These premises have been inspected by a Certified Access Specialist (CASp).

The Public Accommodation areas of this complex have received a CASP Inspection on May 23, 2012 and has received the "CASp Determination Pending" status. The management is maintaining a list of barriers who's removal is considered readily achievable as defined in ADA 36.104 and has a schedule for the removal of those barriers

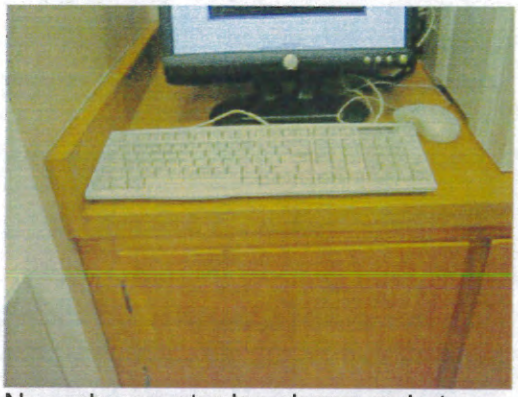
No under counter leg clearance but parallel approach compliant

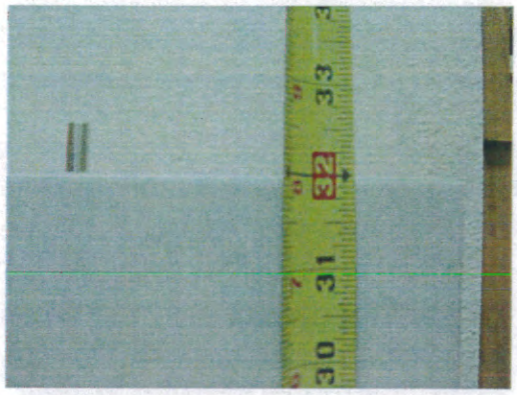
Pay station compliant for reach heights

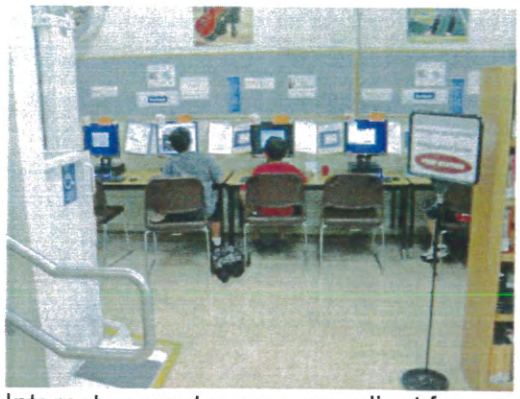
Internet computer area compliant for path of travel access and turning radius

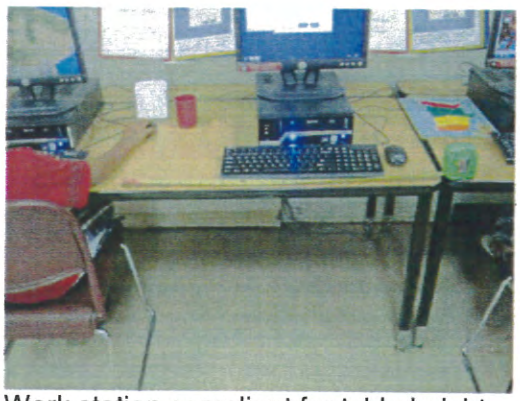
Work station compliant for table height, leg clearance and clear width of station. Not all stations have access clearance. Recommend identifying this station with ISA sign

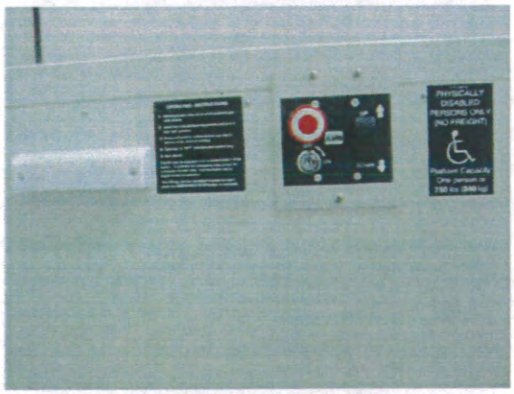
Disabled access lift for upper level.
Compliant for access path, size, operation and controls

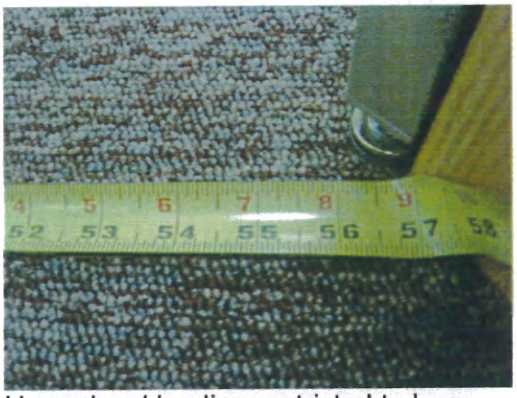
Upper level landing restricted to less than 60" with movable partition

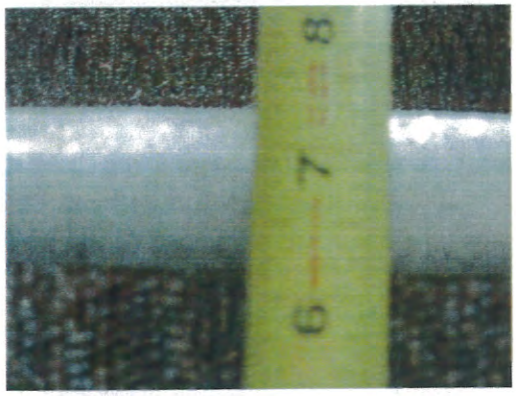
Stairs to upper level. Compliant except for required upper and lower tread marking – 2 -4" stripe of contrasting color

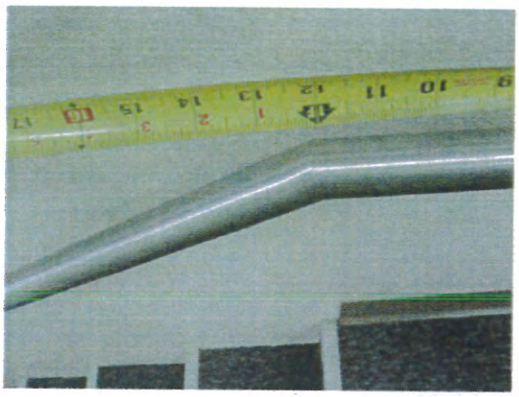
Handrail extension of a protruding object. Needs connecting down to floor

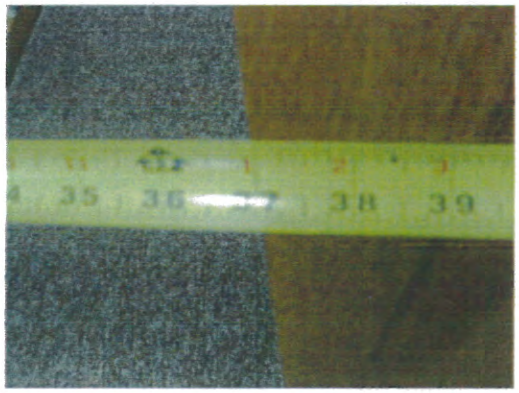
End aisle with typewriter table restricted to less than 36" at table. Relocate table to another location

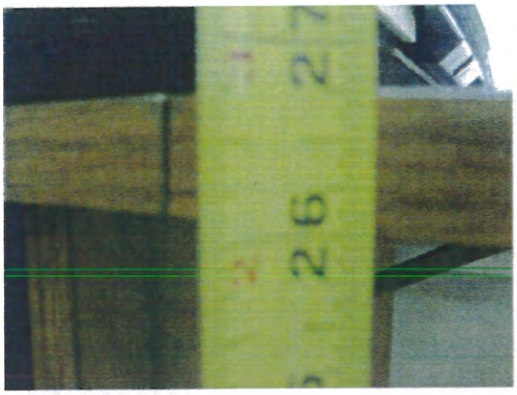
Table width clearance not compliant at less than 30". Replace with compliant table

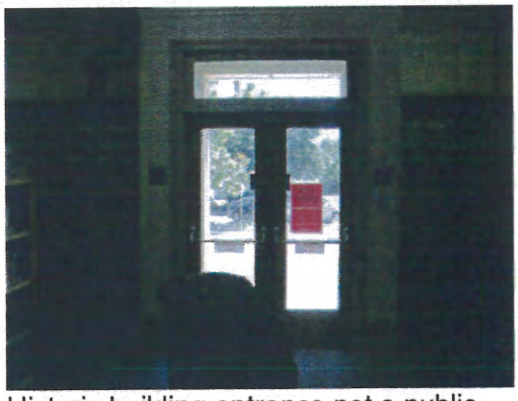
Public toilet rooms at entry to library no accessible compliant due to door widths and interior clearance. Alternate Unisex restroom provided

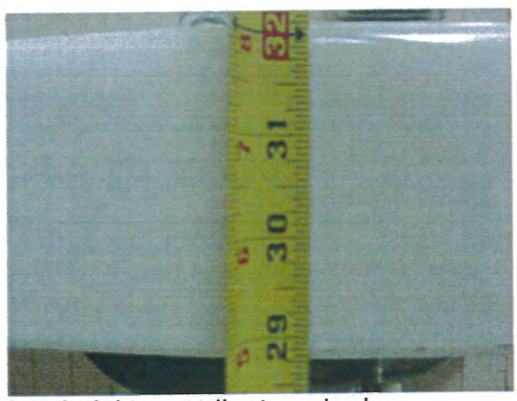
Lav height compliant, under lav clearance short by ¼"

Mirror too high. Reflective surface to be no more than 40" above floor

Hot water supply not insulated

Faucet non compliant. Needs lever handle

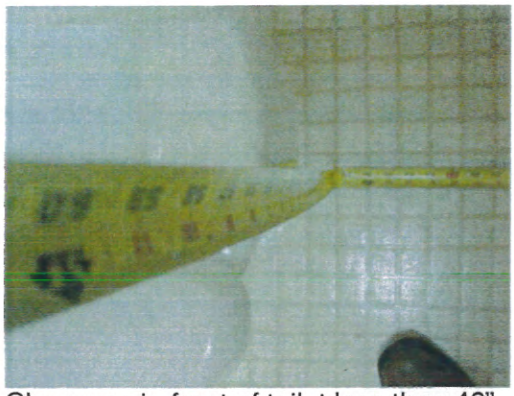
Clearance in front of toilet less than 48". Restricted at one corner of the 30" x 48" access by 10"

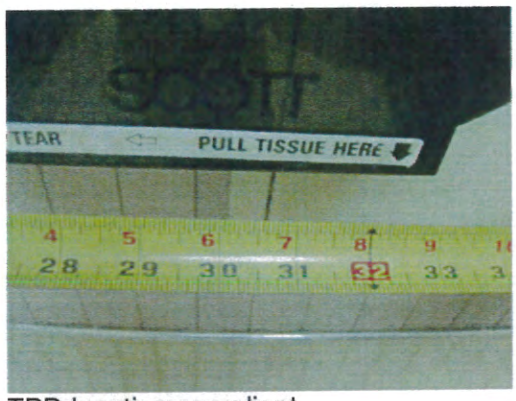
End of bar to be at 54"
